SHIELDED SMD POWER INDUCTORS
SERIES 3631

C-1625812

CUSTOMER DRAWING

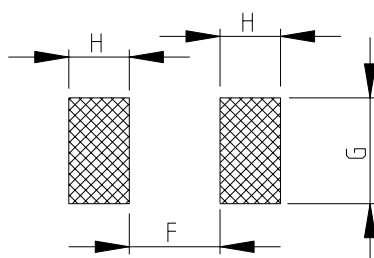
DESCRIPTION AND DETAIL OF CHANGE	EPOXY METHOD CHANGED	
	BEFORE CHANGE	AFTER CHANGE
	EPOXY ALL AROUND TERMINALS (MARKED BLACK AREA)	EPOXY ON FOUR SPOTS (MARKED BLACK AREA)
